Hornsea Project Four

Clarification Note: Justification of Offshore Maximum Design Scenarios

Deadline 3, Date: 21 April 2022

Document Reference: G3.6

Figure 4: Trenching Soil Conditions Heat Map Analysis at Smithic Bank.

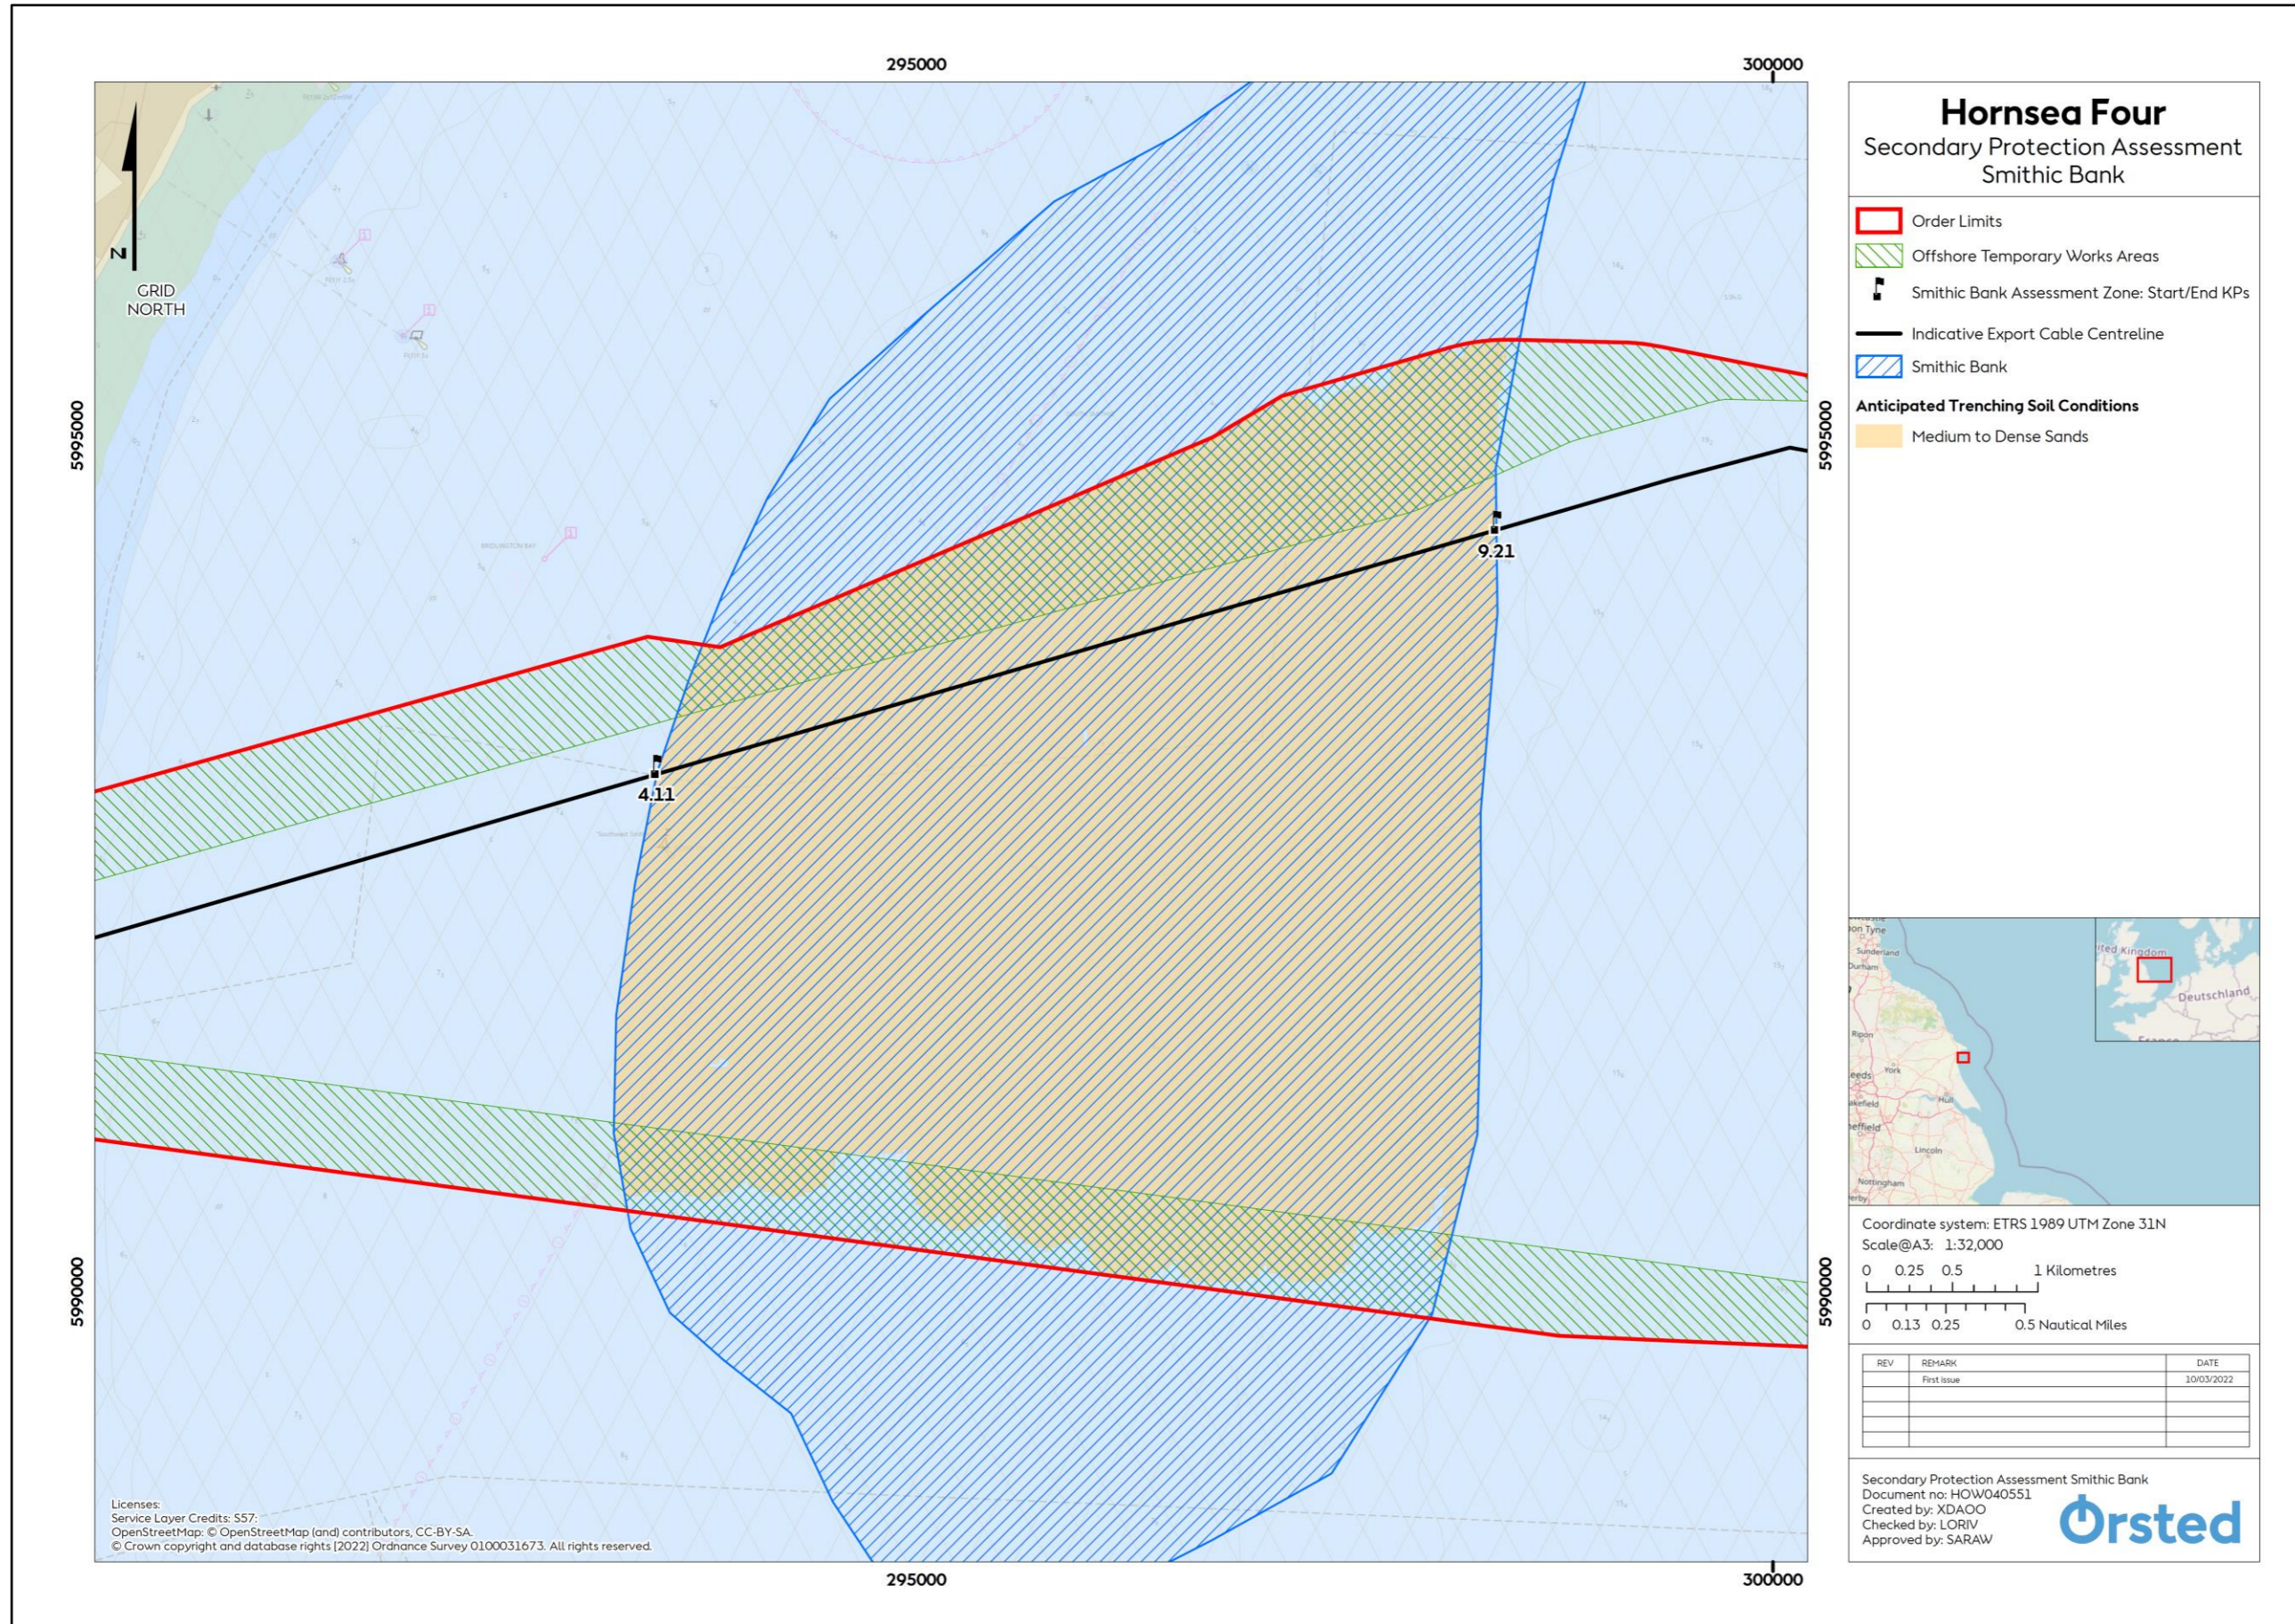
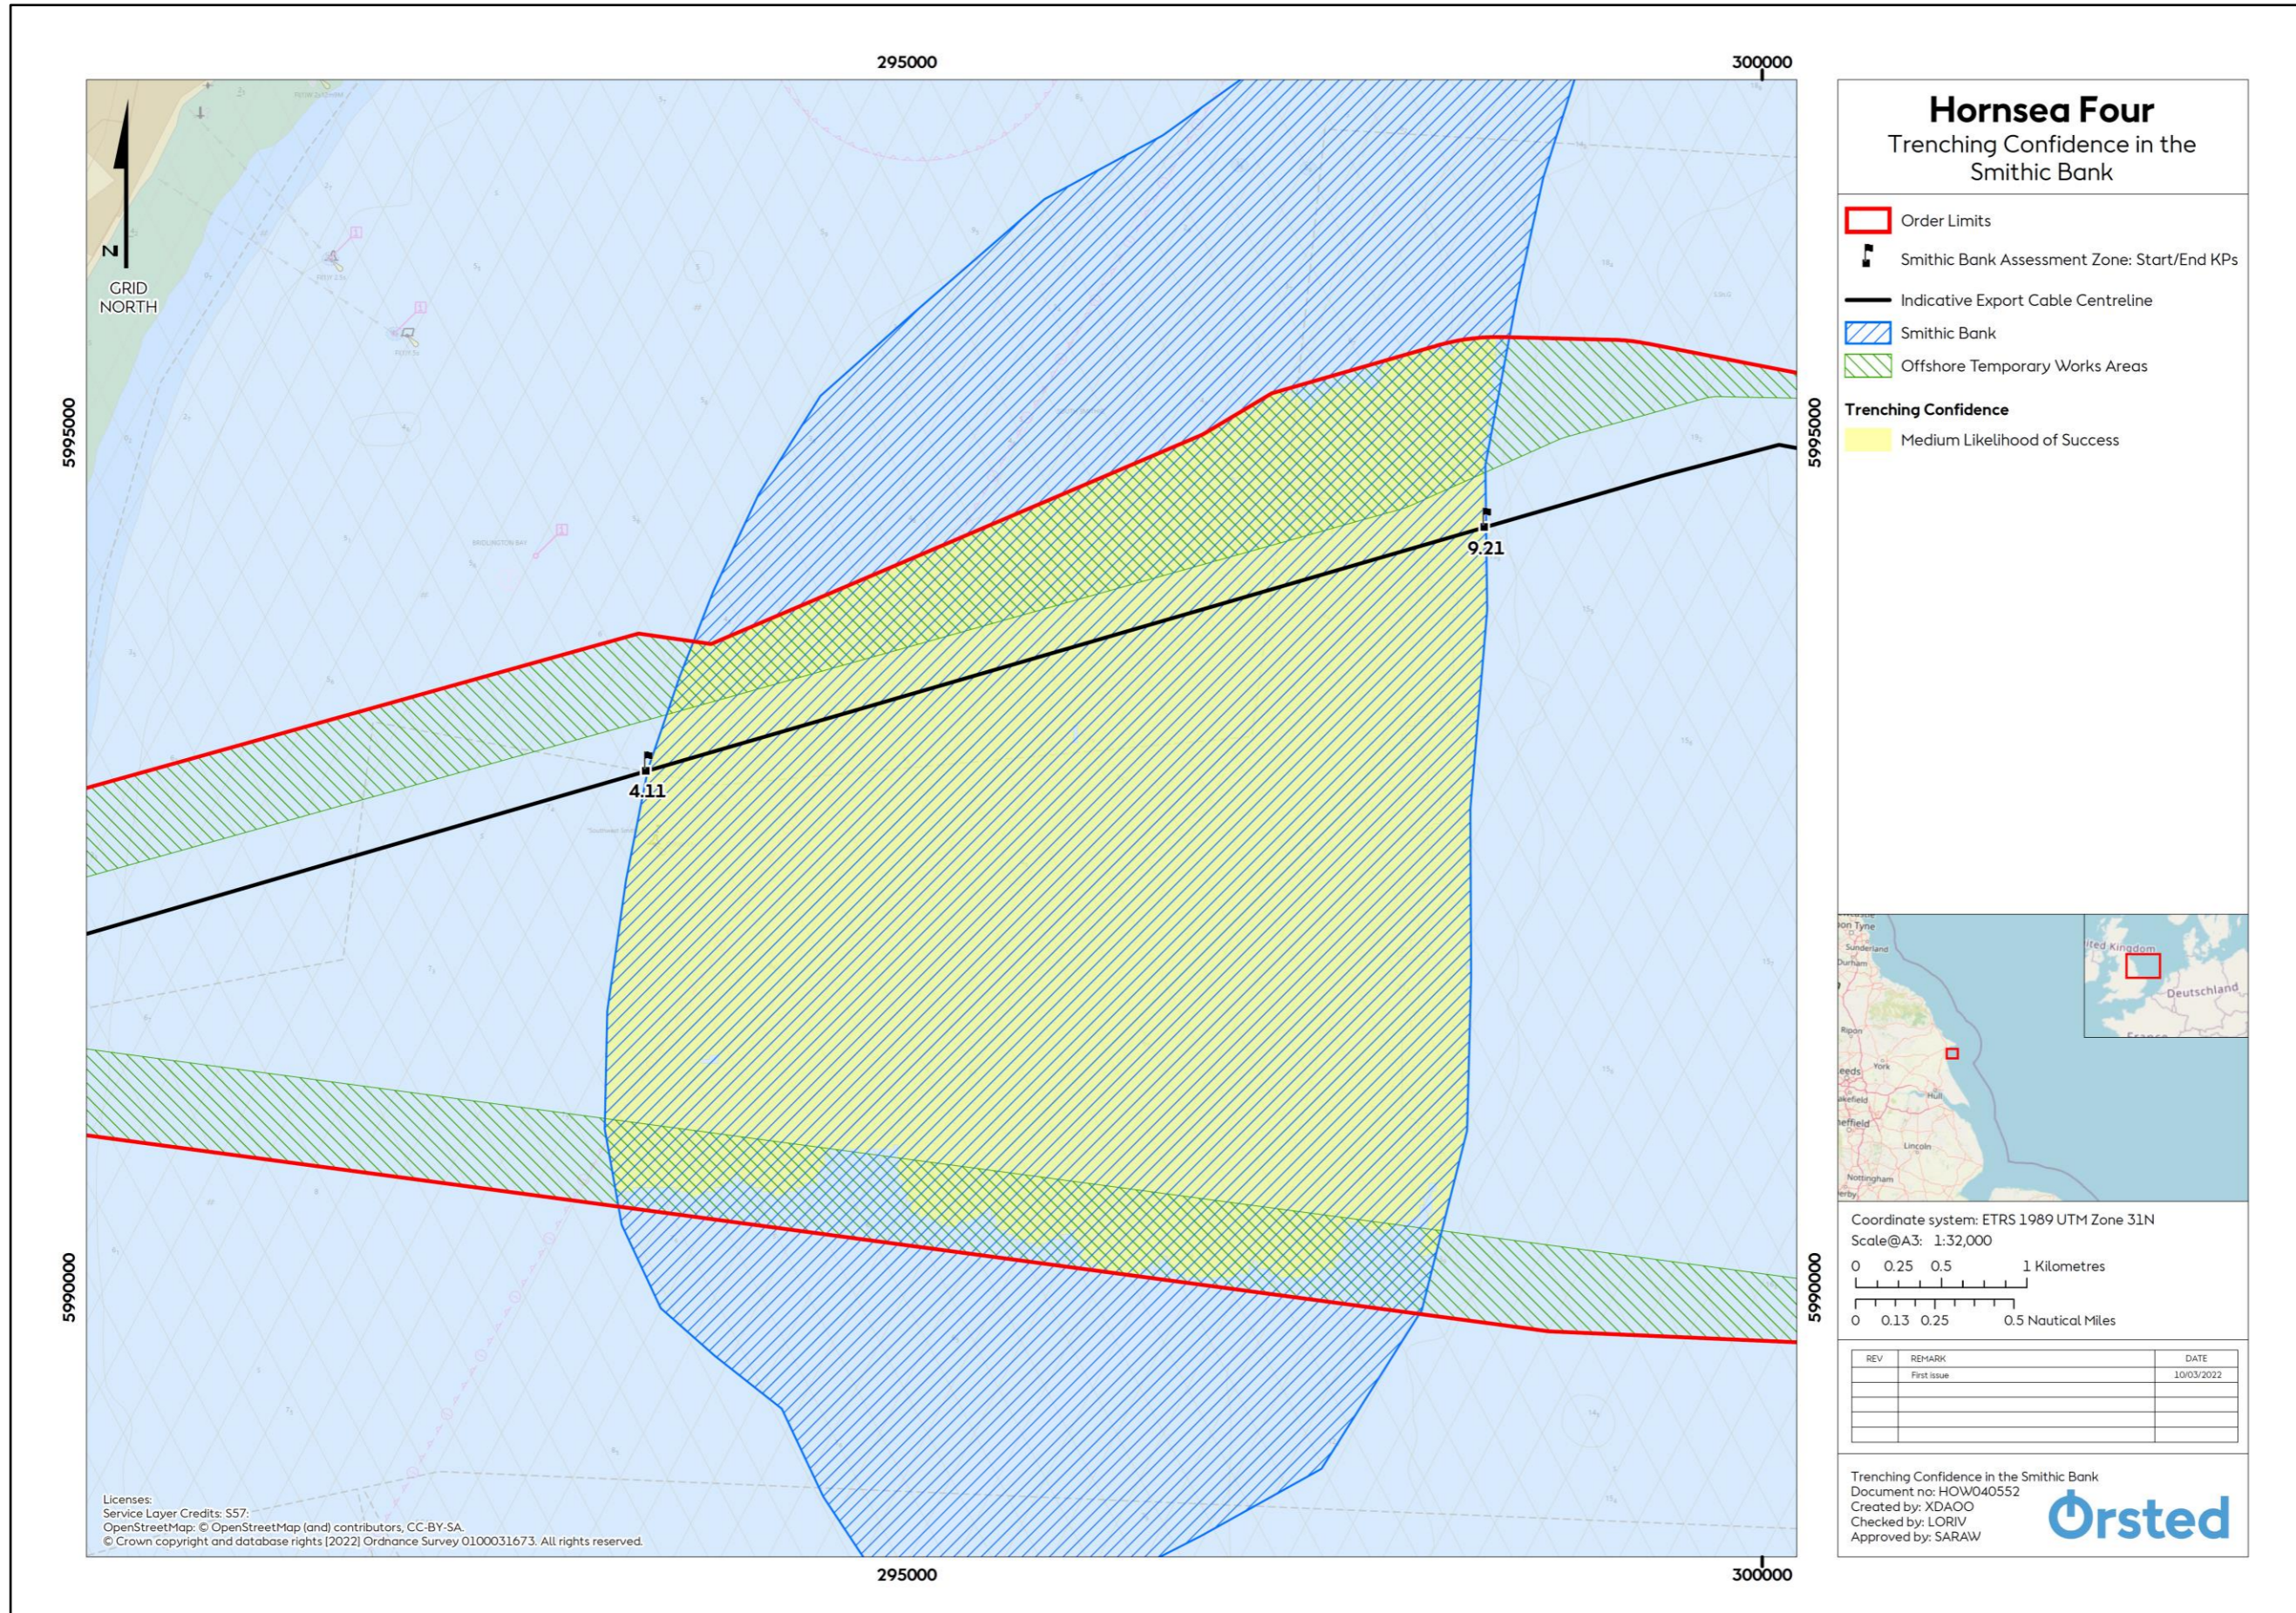
6.2.2.1 In response to Natural England's comments (as set out in [Section 1](#)), and the specific request from Natural England to avoid the placement of rock protection on Smithic Bank as a minimum (approximately 16 m depth contour), and as part of the analysis of the latest site-specific geophysical data, the Applicant has been seeking to reduce the MDS for cable protection across Smithic Bank, where feasible, in order to address concerns. With these considerations in mind, the Applicant proposes to reduce the MDS for cable protection across Smithic Bank. The following sections set out the methodology associated with establishing this reduction, as well as confirmation of what this reduction will comprise.

6.2.3.7 Based on the analysis undertaken using the parameters and information set out in [paragraph 6.2.3.4](#), the confidence level assigned to the soil units (superficial sands overlying medium to dense sands) across Smithic Bank is deemed to be medium ([Figure 4](#) and [Figure 5](#)). This equates to a 95% overall confidence level in relation to achieving target depth of lowering and a requirement for cable protection along 5% of the cables in that area. The assessment concluded that the sediments across Smithic Bank would be suitable for various trenching tools such as jet trenching or ploughing. However, operational constraints due to the limited water depths in the area may impact the type of trenching equipment and vessels that can be used to install the cable. As a result, the likelihood of success of trenching the cable in this area is considered to be medium.

6.2.4.1 Following the analysis detailed in [Section 6.2.3](#), the Applicant proposes that a maximum of 5% of the cable lengths that cross Smithic Bank will require cable protection, compared to the 10% requirement stated at DCO Application.
